3070-89A

Modification Recommended Service Note

Keysight i3070 Series 5 and Series 5i In-Circuit Test System

i3070 test system controller encountered intermittent testhead booting error – i3070 test system controller that uses i3070 09.10p software release may encounter testhead booting issue.

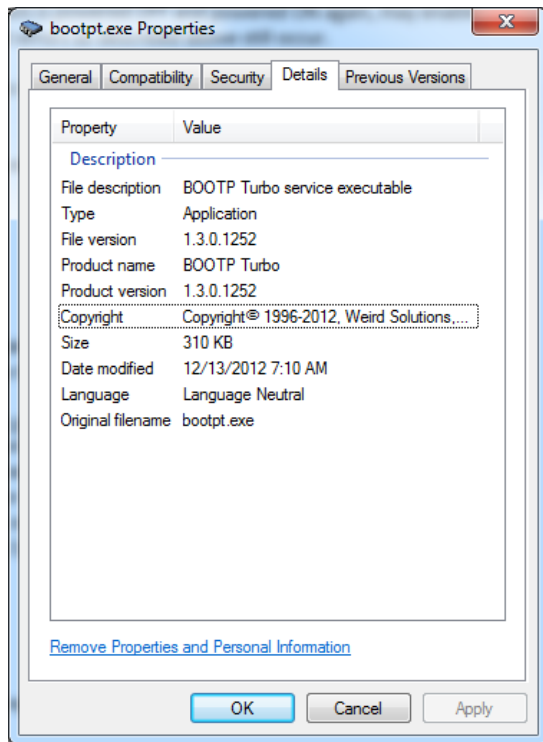
The i3070 Series 5 test system controller that installed i3070 software 09.10p with Windows 7 Operating System may encounter testhead boot-up issue as shown below.

The Bootp Turbo software used in 9.10p is having some conflicts with certain types of PC controller. This could happen to newly shipped systems, or existing systems upgraded from earlier software revision.

Install a newer version of BOOTP Turbo software could resolved the issue.

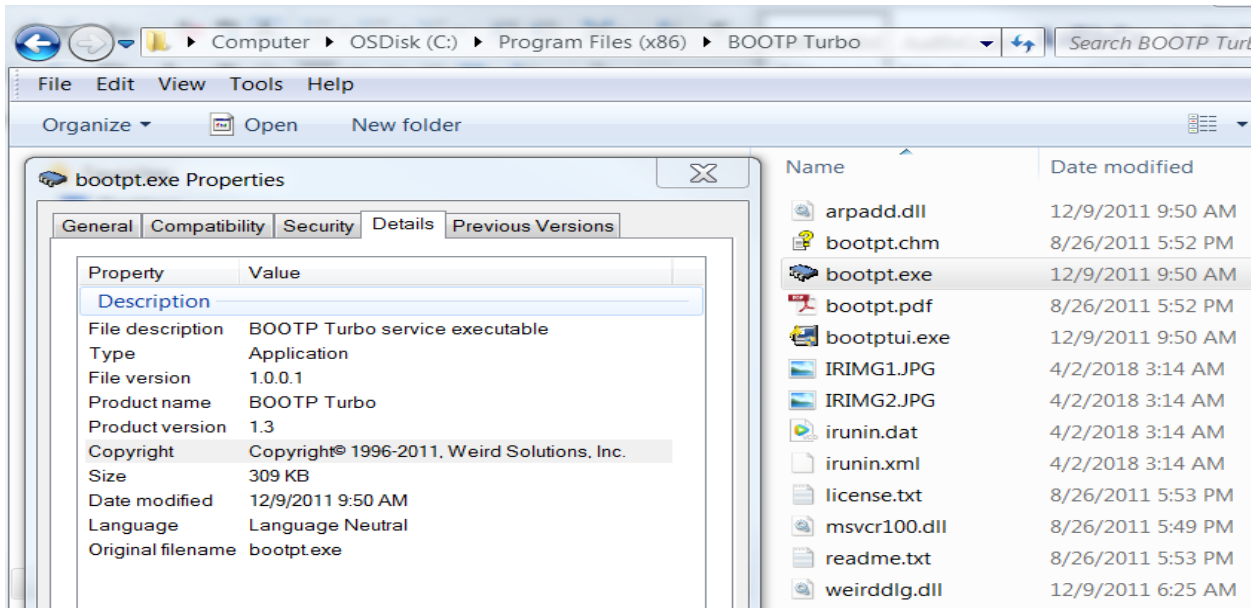
Locate the following file “C:\Program Files (x86)\BOOTP Turbo\bootpt.exe”, right click mouse and select the “Properties”, then select “Details” tab as shown below:

If the Product version is “1.3” and Copyright is “Copyright@1996-2011”, it is recommended to update the BOOTP Turbo software even though the system has not experienced the boot up issue.

The correct Product version is “1.3.0.1252” and the Copyright is “Copyright@1996-2012”
